DEVELOPMENT ASSESSMENT REPORT

Application No.	DA/2020/0346
Address	14 Forrest Street HABERFIELD NSW 2045
Proposal	Demolition of existing rear extension, construction of single storey pavilion and basement carpark.
Date of Lodgement	12 May 2020
Applicant	Mr Domenico Alvaro
Owner	Mr Domenico Alvaro Mrs Susan A Alvaro
Number of Submissions	One (1)
Value of works	\$488,675.00
Reason for determination at Planning Panel	Clause 4.6 variation exceeds 10%
Main Issues	Depth of excavation, landscaped area, built form, length of additions
Recommendation	Refusal
Attachment A	Reasons for refusal
Attachment B	Plans of proposed development
Attachment C	Clause 4.6 Exception to Development Standards – Depth of Excavation
Attachment D	Clause 4.6 Exception to Development Standards – Landscaped Area
Attachment E	Statement of Heritage Significance
Attachment F	Conditions of Consent (in the event that the development is approved)

Figure 2 – Eastern (Streetscape) Elevation – This extract highlights that the lateral extension will be highly visible from the Forrest Street.

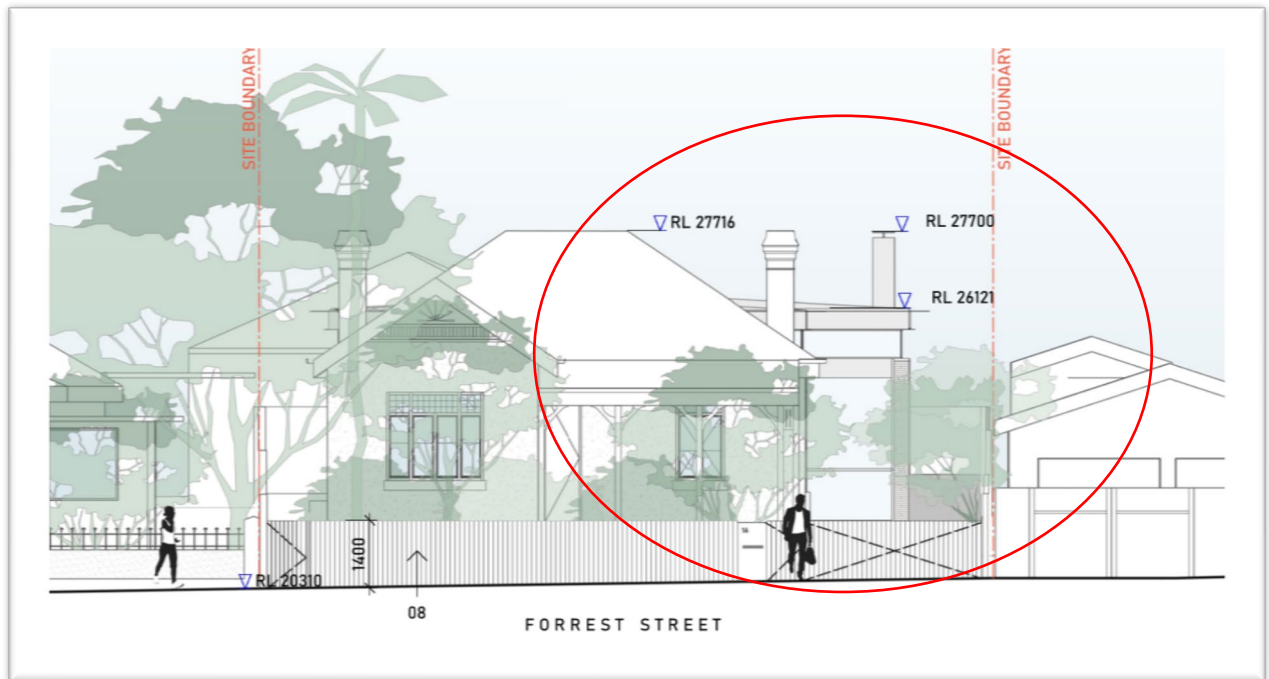
The current proposal seeks consent for the creation of a new lateral extension along the northern boundary of the site, relating to the proposed living room. This lateral extension results in a modern and conflicting built form presentation to the streetscape and is not in-keeping with the objectives or controls of the Haberfield Conservation Area. Analysis of the provided survey plan and proposed floor plans has revealed that the proposed lateral extension is to be setback roughly 26m from the front boundary, have a finished floor level 1.1m higher than the existing footpath and result in an overall height of 4.7m. This built form is best demonstrated by the eastern elevation provided by the applicant (see figure 2 below), which highlights that the proposed lateral extension will be readily visible in the streetscape.

Such a design outcome results in a direct contrast to the values of the conservation area, which has had a high degree of emphasis place upon retaining and enforcing existing front and side setbacks to ensure that the original dwelling house is the focus point of the streetscape.

In this instance acceptance of the proposed lateral extension results in a development pattern not in keeping with the values of the original garden suburb and current planning controls which have consistently and strongly required the retention and protection of original garden suburb pattern of development (detailed in figure 3 below). As seen within figure 3 below the original garden suburb pattern of development actively seeks to have side boundaries unobstructed by development, in order to accommodate a driveway down one side and landscaping/ pedestrian access down the other. A “landscaped setting” and adequate open space between buildings is not maintained in the current design.

Council’s Heritage Advisor has reviewed this proposed lateral extension and outlined strong objection to such a design scheme, outlining that acceptance of such an outcome will significantly disrupt and diminish the established pattern of development and garden suburb nature which Haberfield is recognised for. The proposed lateral extension not supported and the application is therefore recommended for refusal.

Figure 3 – Established and desired development pattern

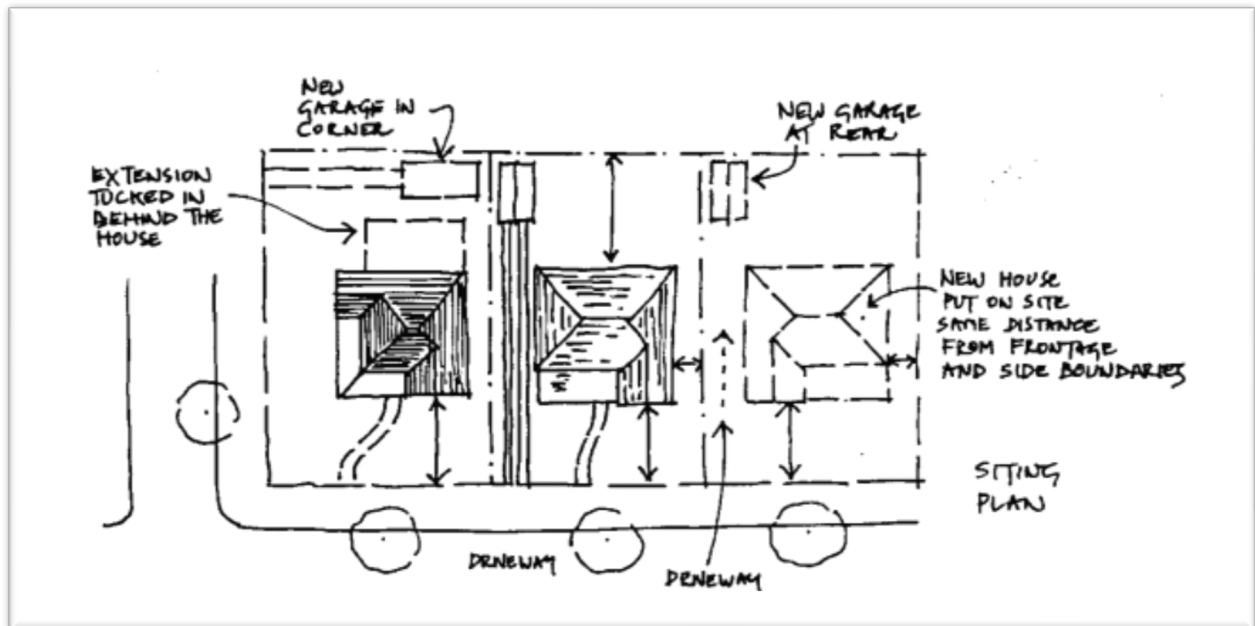
This pattern of development directly attributes to the garden suburb setting and historical significance of separate houses on individual lots, with the suburb originally marketed as the antithesis of the unhealthy crowded inner suburbs of the period. Acceptance of the proposed lateral extension will result in a built form which removes this significant pattern of development through a built form which blocks the existing driveway.

Figure 4 – Roof Plan provided by applicant – Extent of additions compared to original dwelling detailed within red circle.

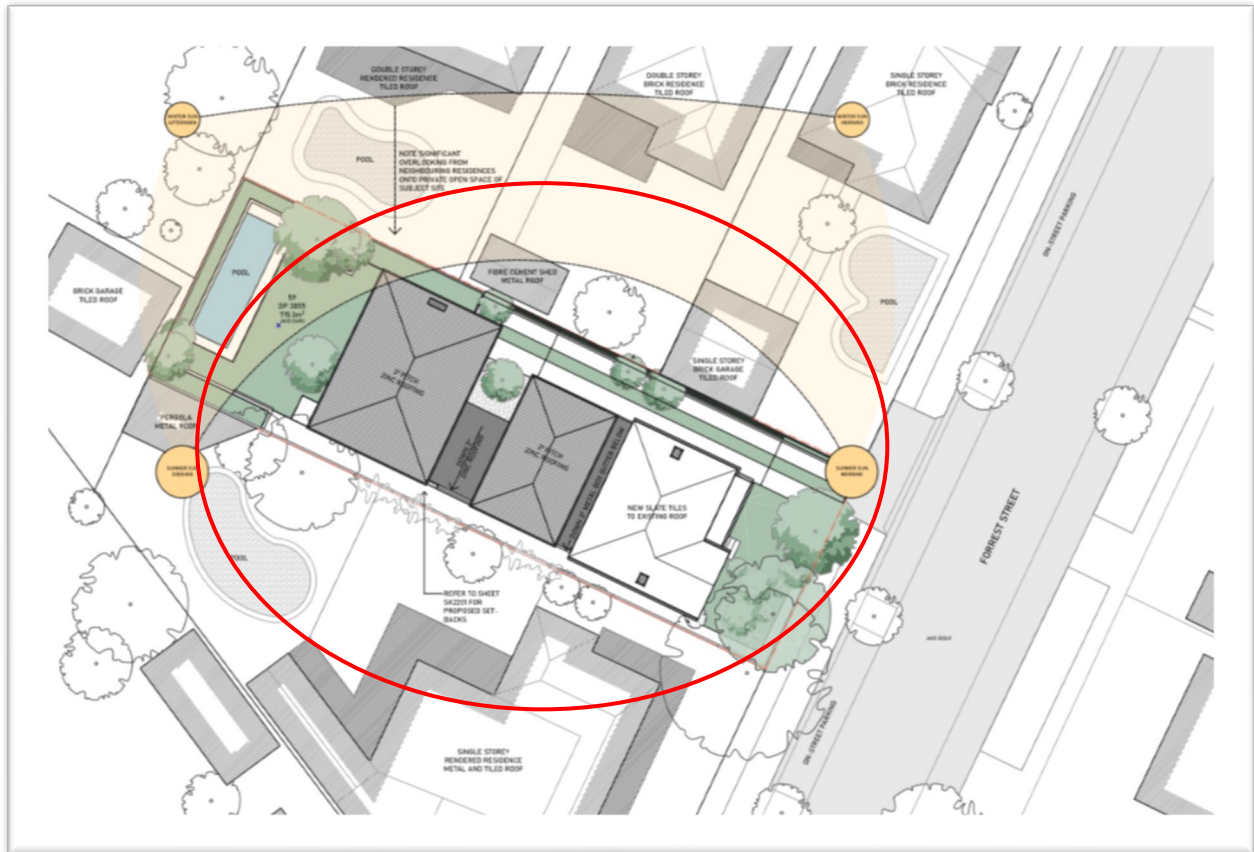
The current proposal seeks consent for a rear addition which is substantially larger than the original house and results in a built form which is not of a similar bulk or shape to that of other designs within the conservation area. The length of the proposed built form is best illustrated in figure 4 below – roof plan provided by the applicant.

The proposed length of the addition is largely driven by the proposed courtyard in front of the basement and the internal stairs providing access to the basement. The removal of the basement, associated courtyard and internal access stairs would provide opportunities for the overall length of the addition to be lessened and result in a built form which is in-line with the current and desired future character of the area. A reduction to the overall length of the addition would also provide opportunities for additional on-site landscaped area to be created ensuring greater compliance with the minimum required 50% landscaped area, improved solar access for neighbouring sites to the south and reduced impacts of bulk/scale for neighbouring sites.

Council's Heritage Advisor has reviewed the proposed length of the additions and also expressed concerns regarding the length and resulting out of character bulk and scale. The proposed variation to clause 2.6 (g) is not supported and the application is recommended for refusal.
